*Meeting Notes*

Project / No. King Open and Cambridge Street Upper Schools Community Complex / 14054

Subject Community Preview

WILLIAM RAWLIN ASSOCIATES | ARCHITECTS, INC. | ARROWSTREET  
**OPTION 1: SHARED SPACES FRONT ONTO CAMBRIDGE ST**  
 1B - THREE SIDED PLAZA

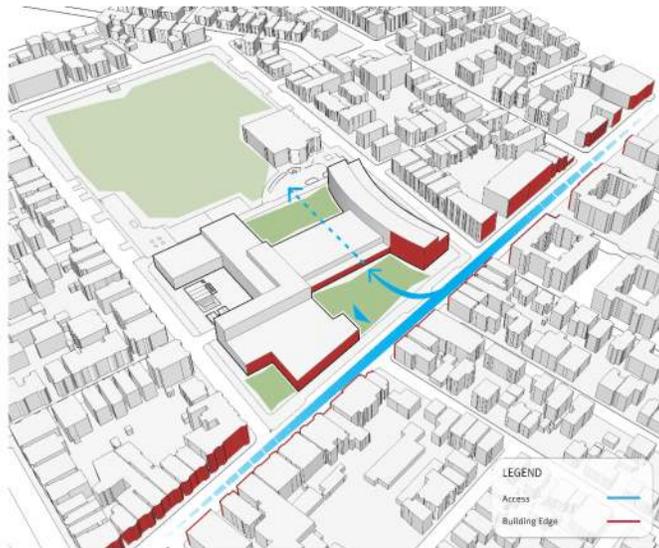
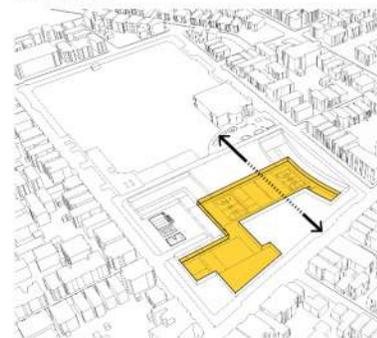
1. School Design Comments
  - a. Makes great sense as a community school.
  - b. Like how it seems more compact – not walking as far to get to gym, etc.
  - c. Give CSUS more of a presence on Cambridge Street. Seems a bit hidden.

- d. Schools should be flipped. King Open on Berkshire and Upper School on Willow more direct connection to Youth Center.
  - e. Where is the person who buzzes people in? Is access to cafeteria and gyms pre check-in a concern?

- f. Love the curve
  - g. There is more sun in this scheme – better.
  - h. Current fenced in area is not used. It will be a plus to make the open space more inviting.

- i. Some Parents, teachers, and students preferred the separation between upper and lower schools\*
    - i. Avoid commotion of older students intimidating or knocking over younger students.

- v. Some of the older children prefer not being lumped with the younger kids.
2. Open Space Comments
  - a. Parents generally want shared space to move forward and to have back open space be even bigger.\*

- i. Front space is not seen as being used enough.
    - ii. Consider scale of civic space. Is it too big?
  - b. Will green surrounded on three sides on Cambridge Street really be used on the north side of the building? A corner plaza seems better in this aspect.

- c. Need separate playgrounds
    - i. Use City Sprouts to divide upper and lower playgrounds.
  - d. How many people can fit on the plaza?
  - e. People don't use space in front of Library and School very much now as there is too much traffic.

- f. Where does City Sprouts go?\*
  - g. Open space connected to the field is good.
3. Pool Design Comments
  - a. Pool included is nice. Kiddie pool is a great idea.\*

## OPTION 2: SHARED SPACES ALIGNED NORTH TO SOUTH

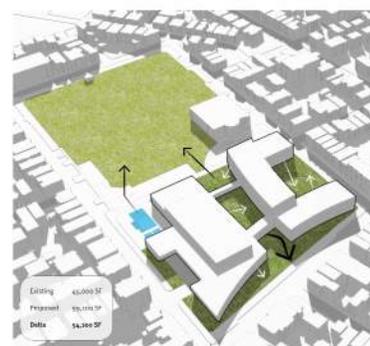
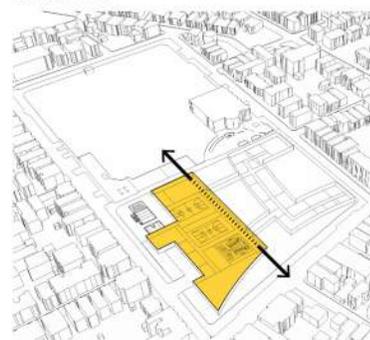
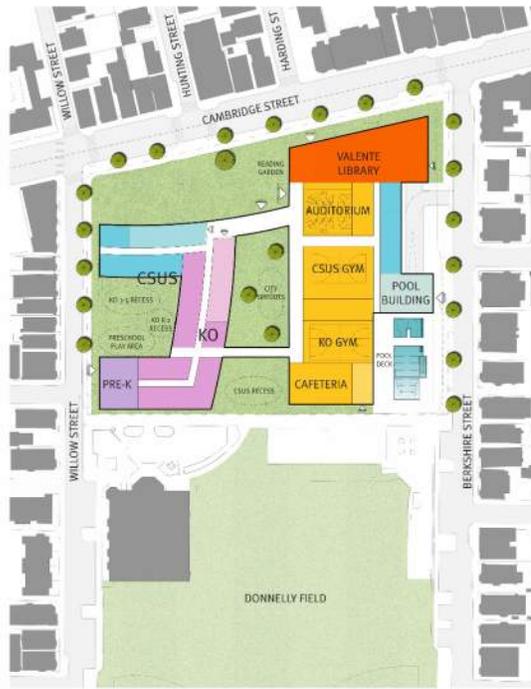
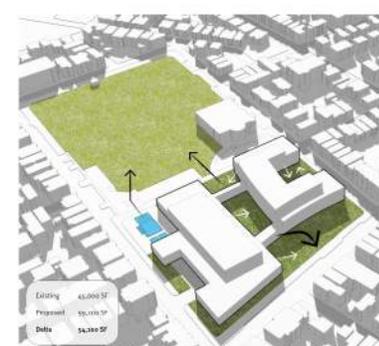
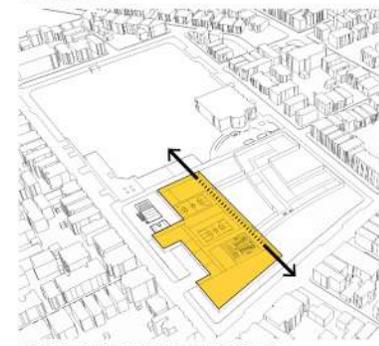
1. School Design Comments
  - a. A common first reaction which did not happen with scheme 1 is “Where’s the entrance?” and “How would each school have their own?”\*

- b. Seems way too long for kids to walk to gym and cafeteria
  - c. KO parent likes division of space in Bi-Part Scheme
  - d. Community members appreciate accessibility of amenities after hours.

- e. Sunlight getting deep into the site from the south is great.
  - f. Scheme 2 seems to have more usable space for the kids – better. Also, the drawings where buildings are closer to the street offers more recess space – better.

- g. Some parents preferred the idea of a more unified school.\*
    - i. Encourages kids to be able to look ahead to the older kids, be mentored, and not have a break in the school experience.

- v. Like Community functions separate for clarity of use.
2. Open Space Comments
  - a. 50/50 mix on having a closed garden/play space
  - b. Any way to keep the sycamores and ancient apple tree in the current courtyard?

- c. How is roof used? Can there be usable open space on the roof?
3. Library Design Comments
  - a. Question as to why Valente is smaller in 2A
4. Traffic Comments

- a. Concerned about drop-off concentrated all on one side. \*
  - b. Parents will stop wherever is convenient.
  - c. Bike parking at garage.
